STAFF REPORT AND RECOMMENDATION ON APPEAL

APPEAL NO.: A-6-LJS-02-068

APPLICANT: Poseidon Point, LLC

PROJECT DESCRIPTION: Demolition of an existing single family residence and swimming pool and the construction of a new, approximately 5,790 sq.ft., two-story single family residence with attached two-car garage, pool, hardscape and landscape improvements on a 0.30 acre blufftop lot.

EXHIBIT NO. 2
 APPLICATION NO.
 A-6-LJS-02-66
 Site Plan

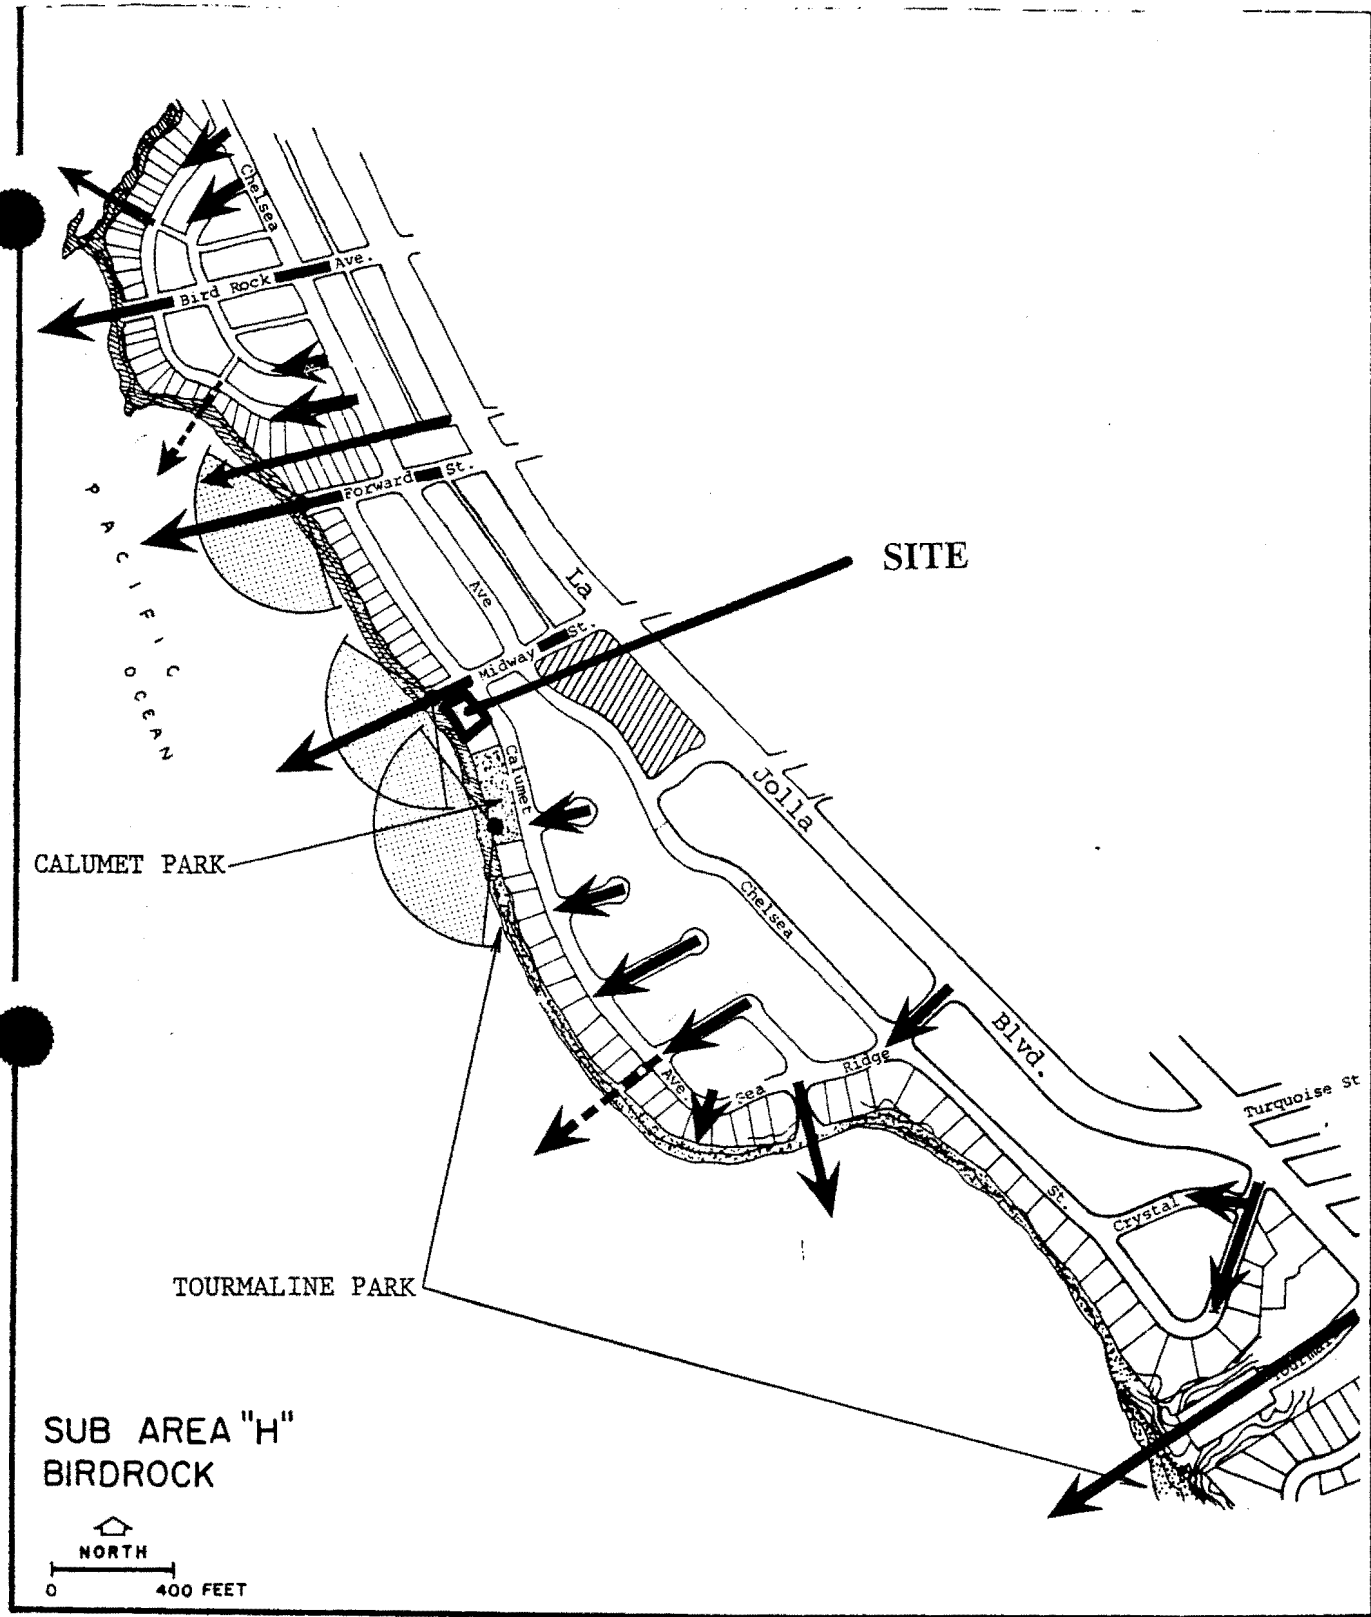
In addition, with regard to the proposed landscaping, as shown on the landscape plans, there appears to be both existing and proposed landscaping but the plans are not clear as to which plants that are remaining adjacent to the designated view corridor (north side yard) and along the rear portion of the site (south side yard) will be low level vegetation (3 ft. or lower). Also, at the northeast corner of the property adjacent to the designated view corridor, the landscape plans show a hedge for screening purposes that will be planted along this frontage extending in a westerly direction but not all the way to the street end. It remains unclear whether or not this landscaping will impede public views to the ocean along this designated public view corridor. However, as noted in the language of the LDC cited above, for those project sites between the first public road and sea that are located within a view corridor designated by the certified land use plan (as is the case with the subject proposal), the development should be designed to preserve, enhance or restore the designated public view. If the north side yard area is not maintained free of vegetation (no greater than 3 ft. in height, such that tall trees or a hedge is planted, views of the ocean along this corridor would be affected. As such, it appears that through

Another potential concern raised by the appellant is with regard to whether or not the City analyzed the potential view impacts associated with a proposed pool fence in the west side yard. However, neither the site plan or the permit and findings describe the proposed pool fence. Nonetheless, fences or other safety devices are required to be installed around new swimming pools pursuant to the Land Development Code. As noted in the LDC language cited above, only open fencing is permitted in the view corridor to enhance public views and to prevent a walled off effect. In the Coastal Overlay Zone of the City's LDC, open fencing must be at least 75 percent "open". Thus, it is important that fences in the side yard areas meet the requirements of the code for open materials to assure any existing public views are maintained and potentially enhanced. The appellant has therefore raised a substantial issue regarding conformity of the proposed project with the public view protection policies of the certified LCP.

- a. A view corridor a minimum of 10 ft. wide shall be preserved along both the north and south side yard areas. All proposed landscaping in the north and south side yard areas shall be maintained at a height of three feet or lower to preserve views from the street toward the ocean. All new landscaping shall not exceed a height of three feet.
- b. All landscaping shall be drought-tolerant, native non-invasive plant species. No irrigation shall be permitted on the site.
- c. A written commitment by the applicant that all required plants on this site shall be maintained in good growing condition and whenever necessary, shall be replaced with new plant materials to ensure compliance with the approved landscape requirements.
- d. Any fencing in the side yard areas shall be composed of 75% open materials on top.

GEOLOGIC MAP AND SITE PLAN, 5490 CALUMET AVENUE

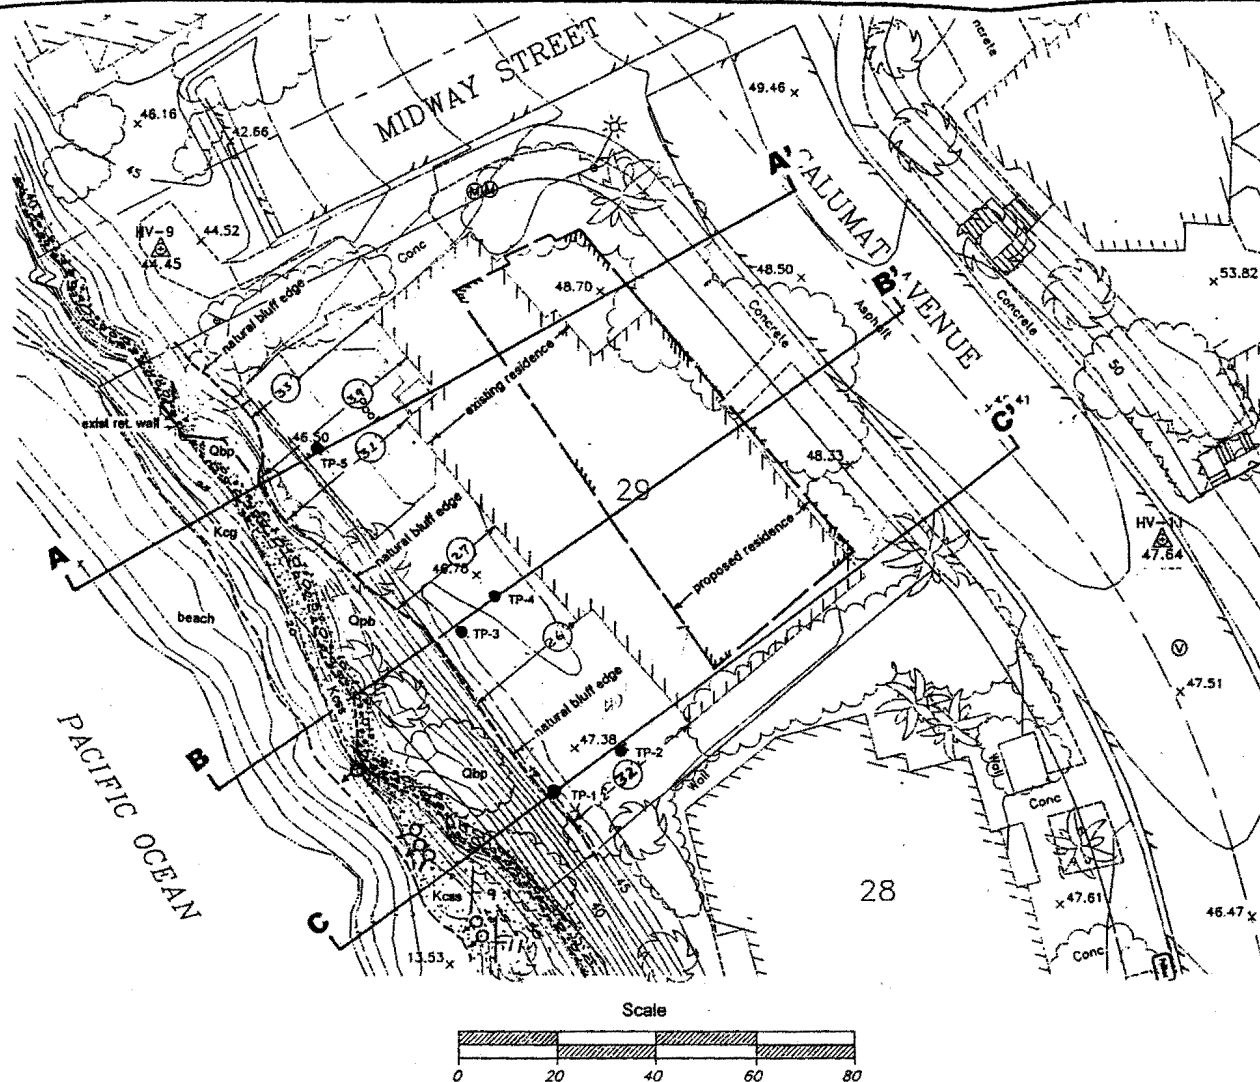
With regard to this issue, the Commission's geologist has also determined that the most seaward bluff edge, as shown in the geotechnical report by the applicant's geologist, is

the accurate bluff edge. This is the bluff edge from which the geologic setbacks should be determined for the proposed swimming pool. Therefore, the appellant has not raised a substantial issue regarding consistency of the City's bluff edge determination with the standards of the certified LCP.

There have been two bluff edge determinations made for the project: one by Coastal Engineer David Skelly for the 5-11-01 plan submittal, and another by geologist Michael Hart, pursuant to July 25, 2001, direction by City Geologist Rob Hawk to identify the "natural" bluff edge, which was subsequently shown in the 11-2-01 and 12-19-01 plans. The Commission file contains only the 12-02-01 plans.
